UNITED STATES PATENT AND TRADEMARK OFFICE

| Office Action Summary | Application No. 10/776,541 | Applicant(s) MORAD ET AL. | |

DETAILED ACTION

Hinchely

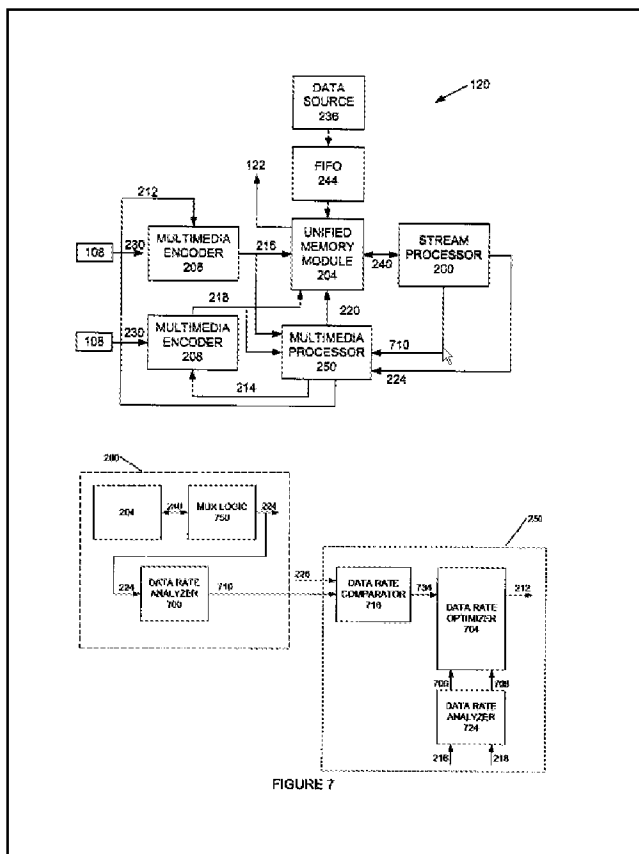
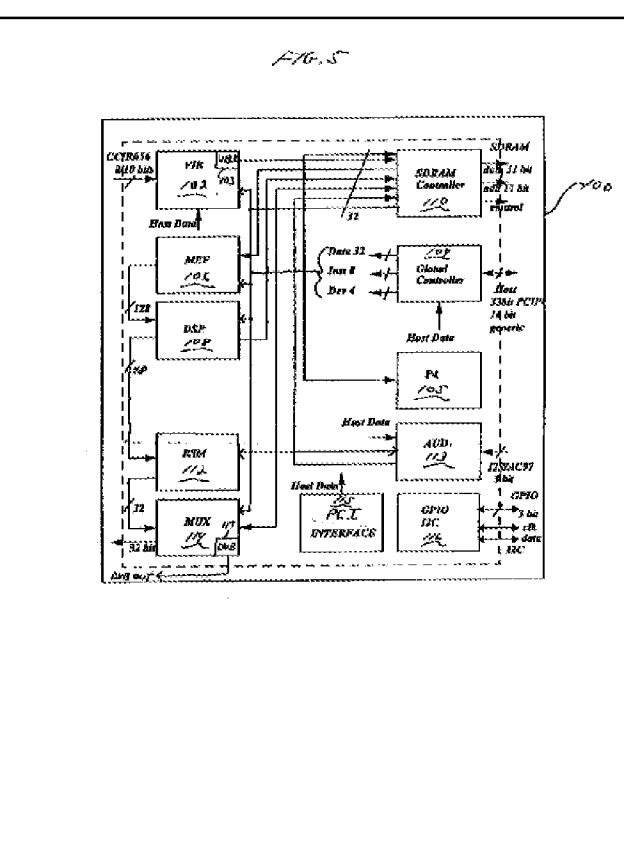
Hinchley discloses multiplexer circuitry (200 of fig. 2, note the stream processor, 200 of fig. 2, comprises the MUX LOGIC (750 of fig. 7) is compliant with MPEG2 standard, which has the same functions as multiplexing circuitry as disclosed above of the present invention) that operates in a first mode and a second mode (MUX logic (750 of fig. 7) performs multiplexing operations that encompass a first mode and second mode). Since Hinchley discloses the MUX logic (750 of fig. 7) have multiplexing operations as modes with recognized standards such as MPEG2, col. 6, lines 12-26, so the MUX logic performs when operating in the first mode produces a first multiplexed stream from first compressed video, first compressed audio, second compressed video, and second compressed audio; and when operating in the second mode concurrently produces the first multiplexed stream from the first compressed video and the first compressed audio, and produces a second multiplexed stream from the second compressed video and the second compressed audio, which is the same the multiplexing circuitry, 114 of fig. 5, of the present invention as disclosed in the specification, [0040], [0061], [0063], and [0064].

Let compare the multiplexing circuit of Hinchley and the present invention as follows:

FIG. 7 is a more detailed block diagram of an embodiment of the stream processor 200 and multimedia processor 250 in accordance with the present invention. The stream processor 200 includes MUX logic 750 which performs conventional multiplexing operations in accordance with recognized standards such as MPEG2 to generate the combined multimedia stream 224. Combined multimedia stream 224 is preferably a program or transport stream as specified in MPEG2. The MUX logic 750 accesses the unified memory module 204 through data line 240 to retrieve the data and the instructions to perform on the data. After performing the required operations, the data 224 is temporarily written back to memory 204, for later transfer to the communications device 112 or other recipient of the Program or Transport Stream 224.

Based upon the comparison above, Hinchley's MUX logic (750 of fig. 7) has the same functions (MPEG2 standards) as Multiplexing processor (114 of fig. 5) of the present invention. Therefore, Hinchley clearly anticipates the claimed features.
